Purple=Proposed Emergency Rules to the 2021 WA State Fire Code (with comments), Green 2021 WA State Amendment

**SECTION 1207
ELECTRICAL ENERGY STORAGE SYSTEMS (ESS)**

FIGURE 1207.11.7.1 ESS VEHICLE IMPACT PROTECTION

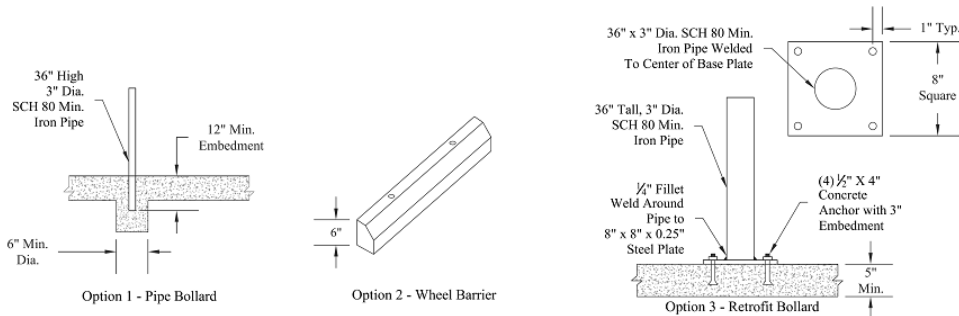
The third and most substantial change addresses the need for a clearly defined area in which a residential garage ESS installation would trigger the "Subject to Vehicle Damage" requirement found in 1207.11.7. The existing language has led to widely varying interpretations and enforcement of impact protection. New language (1207.11.1) has been added to define this area and set the expectation that the barriers are intended to deflect, resist, or visually deter an impact. This language mirrors the existing Section 312.3 in the IFC.

A minimum installation height of 48" within the likely impact area has been added to allow elevation of the ESS as a permissible mitigation option. An exception to this 48" minimum has been included to recognize that a reduced garage opening height would thereby limit vehicle height and allow a lower placement of equipment before additional protection is needed. This exception is inspired by existing IMC Commentary:

A new Figure 1207.11.7.1 has been added to illustrate the zones in which a typical residential garage ESS installation would trigger the need for impact protection. This figure is based on existing IMC commentary related to the installation of fuel-fired appliances that may pose a fire hazard when damaged. The IMC commentary Figure 304.6 (2) has been modified to reflect common ESS installation locations and takes a similar approach to mitigating the risk of impact. New language (1207.11.7.2) has been added to address other than garage locations that may also have vehicle access such as residential driveways, and also allows some flexibility to the AHJ and installer for larger, non-typical, or custom residential garages where the normal path of vehicle travel falls outside of the area defined in 1207.11.7.1.

1207.11.7.1 Garages. Where an ESS is installed in the normal driving path of vehicle travel within a garage, impact protection complying with Section 1207.11.3 shall be provided. The normal driving path is a space between the garage vehicle opening and the interior face of the back wall to a height of 48 in. (1219 mm) above the finished floor. The width of the normal driving path shall be equal to the width of the garage door opening. Impact protection shall also be provided for an ESS installed at either of the following locations (See Figure 1207.11.7.1):

Exception: Where the clear height of the vehicle garage opening is 7 ft 6 in. (2286 mm) or less, ESS installed not less than 36 inches (914 mm) above finished floor are not subject to vehicle impact protection requirements.
